**COUNTY OF SAN MATEO
PLANNING AND BUILDING DEPARTMENT**

SUBJECT: Consideration of the adoption of an Initial Study/Mitigated Negative Declaration, pursuant to the California Environmental Quality Act (CEQA), and a Design Review Permit and Coastal Development Permit, pursuant to Sections 6565.3 and 6328.4 of the County Zoning Regulations, and a Merger, pursuant to Section 7123 of the Subdivision Regulations, to allow construction of a new two-story, 1,971 sq. ft. residence with a 1,015 sq. ft. attached garage on a 5,643 sq. ft. legal parcel on Cypress Avenue, in the unincorporated Moss Beach area of San Mateo County. The project is appealable to the California Coastal Commission.

County File Number: PLN2020-00070 (Love/Mukaeda)

GRADING AND DRAINAGE PLAN

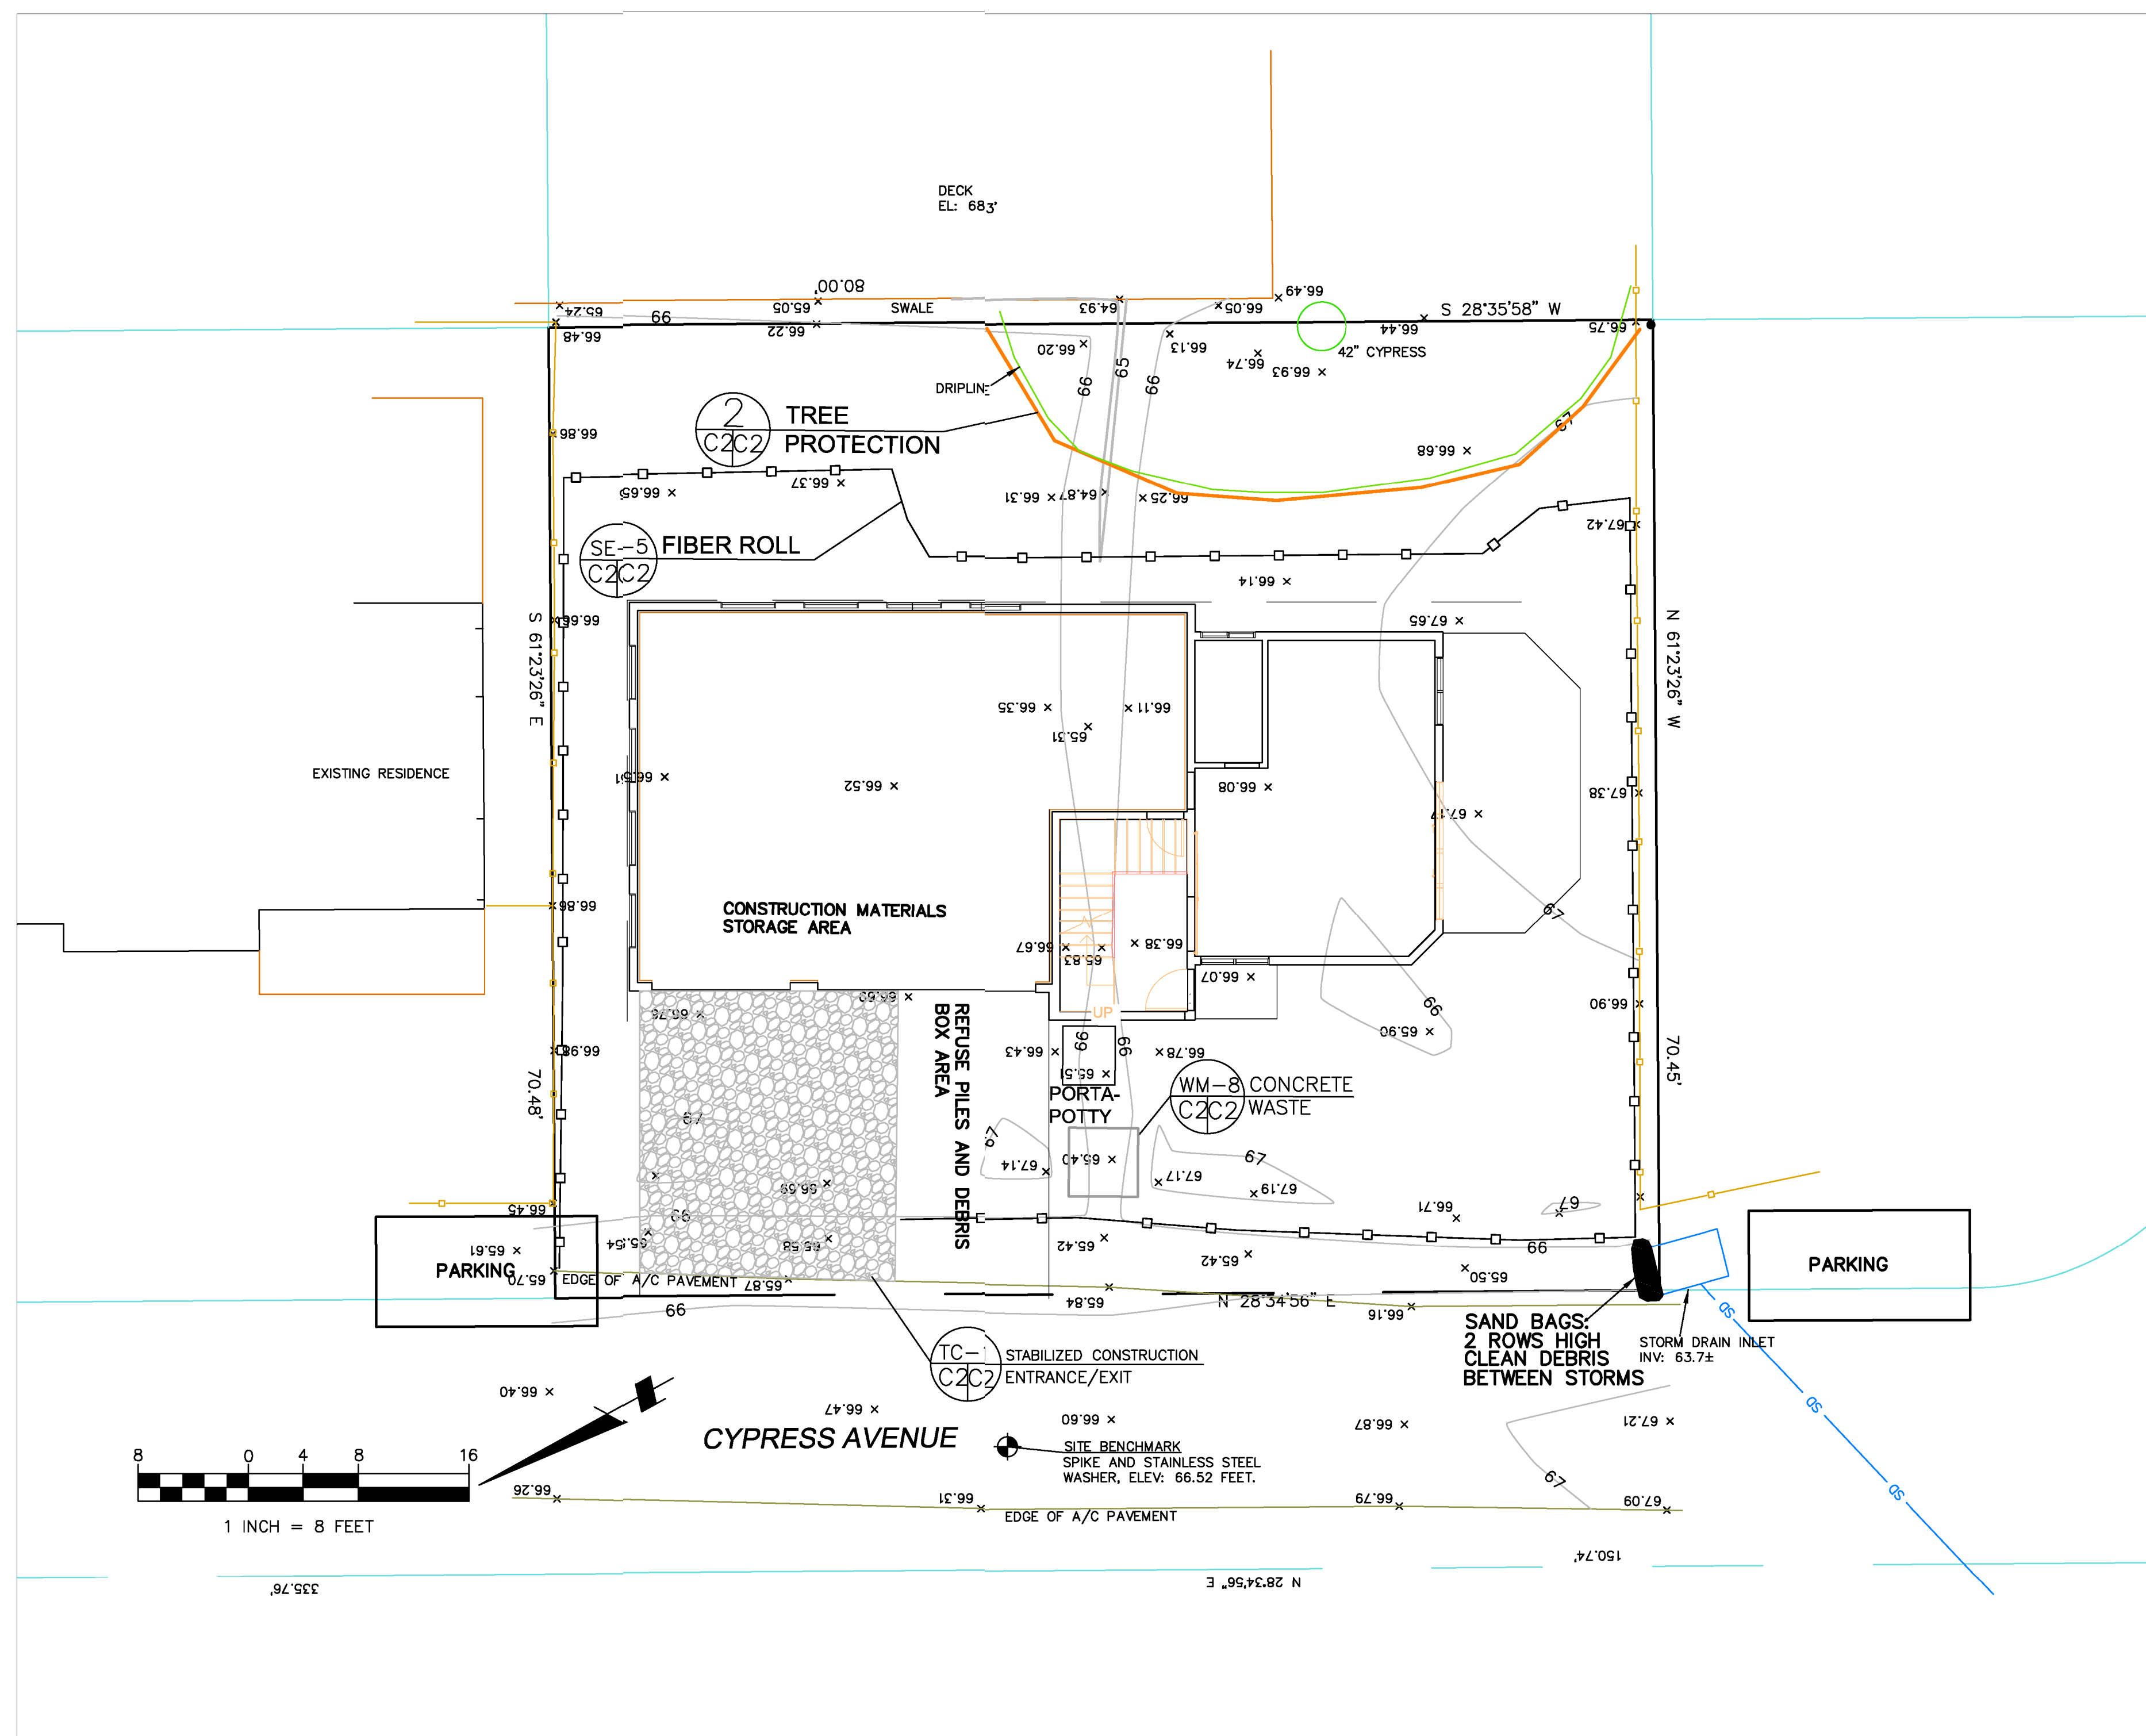
Commenter(s) assert that the size of the proposed swale may not be sufficient and could exacerbate the ongoing flooding problems upstream, along Alton Avenue. Staff's Response: In a response to drainage comments (Attachment G), the Project Civil and Geologist states the previous version of the drainage plan included a proposed concrete block swale with a cross sectional area of 1 square foot (SF) and ending at a swale along the front property line. The swale flows to an existing catch basin with an 18-inch diameter culvert. The revised drainage plan (Attachment G) includes a smooth poured concrete swale with a cross sectional area of 1.66 SF that continues all the way to the catch basin, with a slope of 0.5 percent. The 1.66 SF area is slightly less than the area of the 18-inch culvert (1.77 SF). The inflow from the swale into the catch basin should not exceed the culvert's size, otherwise, there is a chance that the culvert will back up onto Cypress Avenue.

We have been asked to provide information to accompany our latest revision to the Grading and Drainage Plan, Sheet C-1. In the latest revisions, we increased the size of the proposed swale that will replace the existing swale across the middle of the property. There has been some concern regarding the size of the proposed swale and whether or not it will exacerbate the ongoing flooding problems upstream, along Alton Avenue.

1 CD - East (Rear)
1/4" = 1'-0"

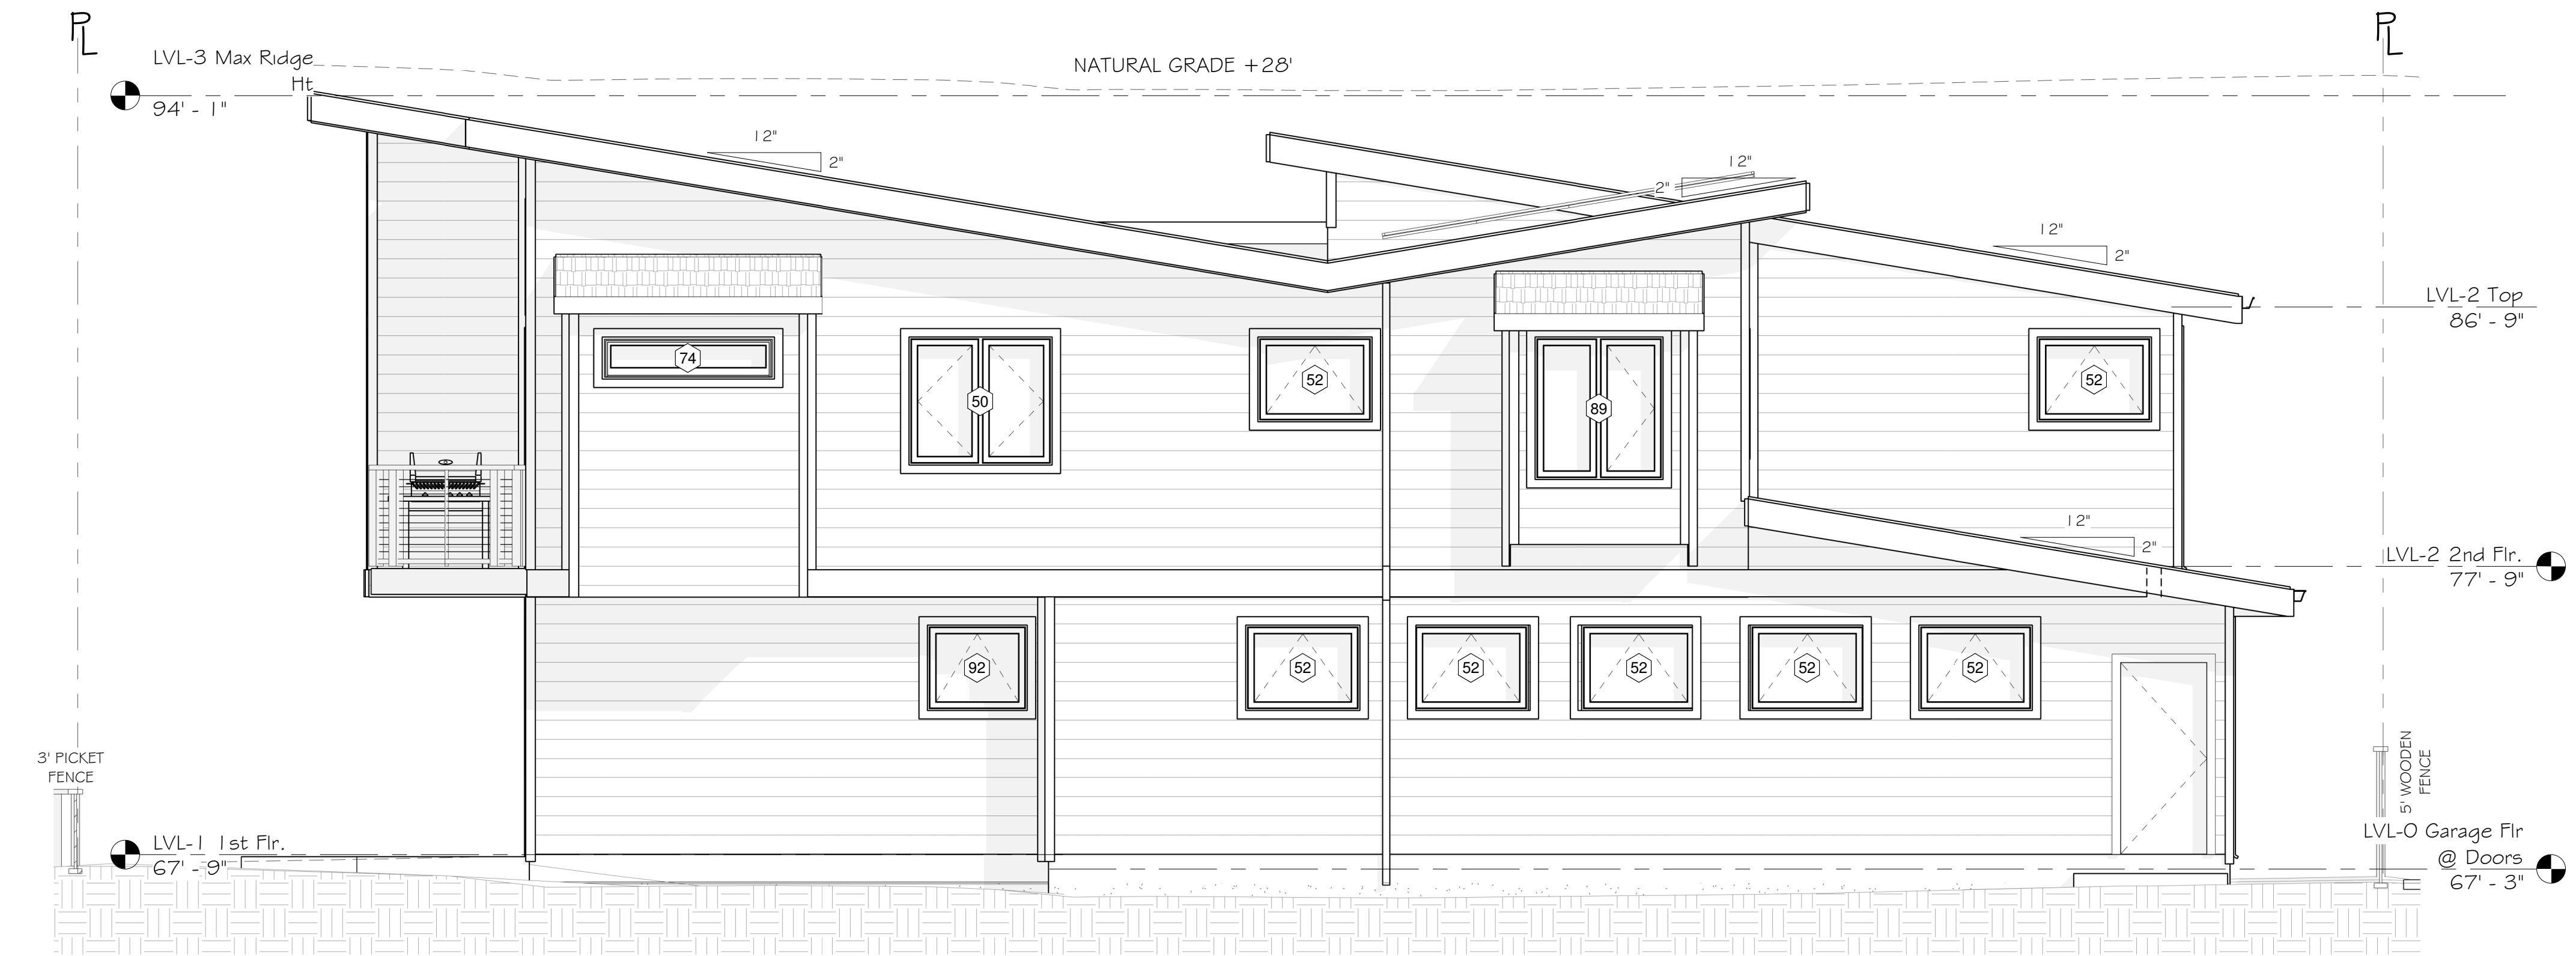
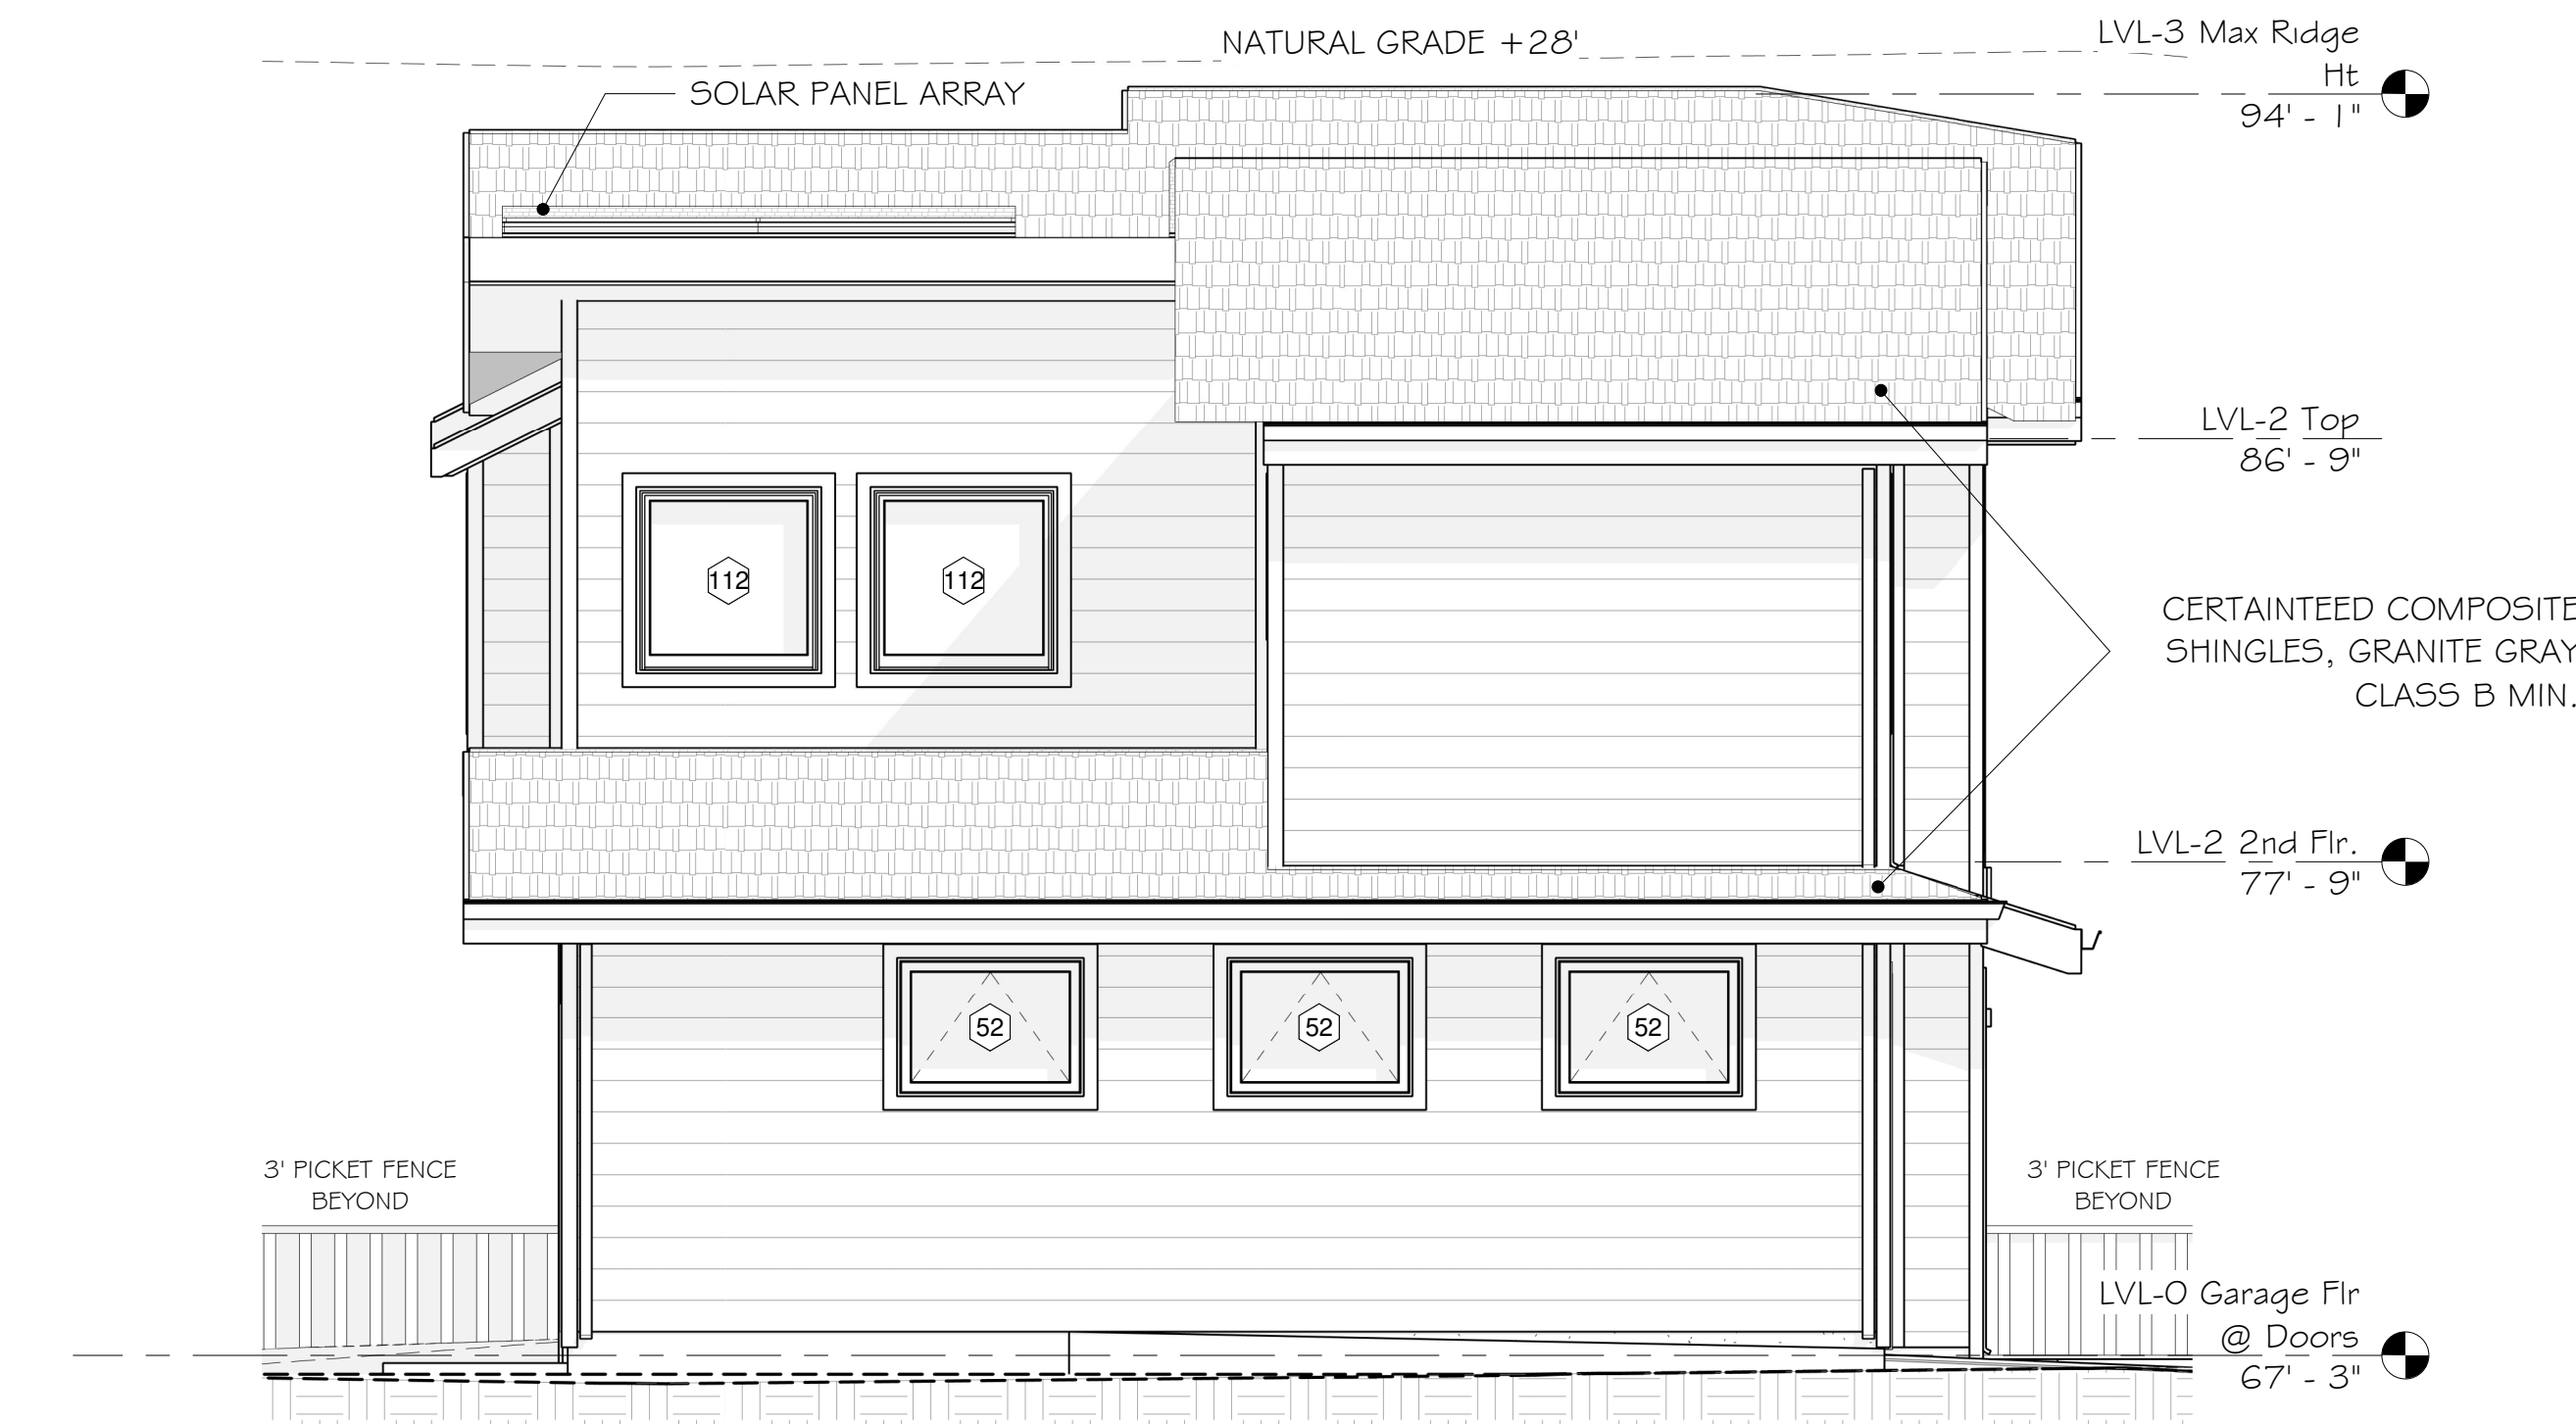
- b. To better comply with Section 6565.20.C.2.a (SITE PLANNING AND STRUCTURE PLACEMENT: Privacy) and Section 6565.20.D.2.b. (ELEMENTS OF DESIGN: Architectural Styles and Features, Openings), both second story windows, three first story windows on "CD - North (Left)" elevation, and one first story window with "92" label on "CD - East (Rear)" elevation on sheet A202 shall be frosted or obscured.
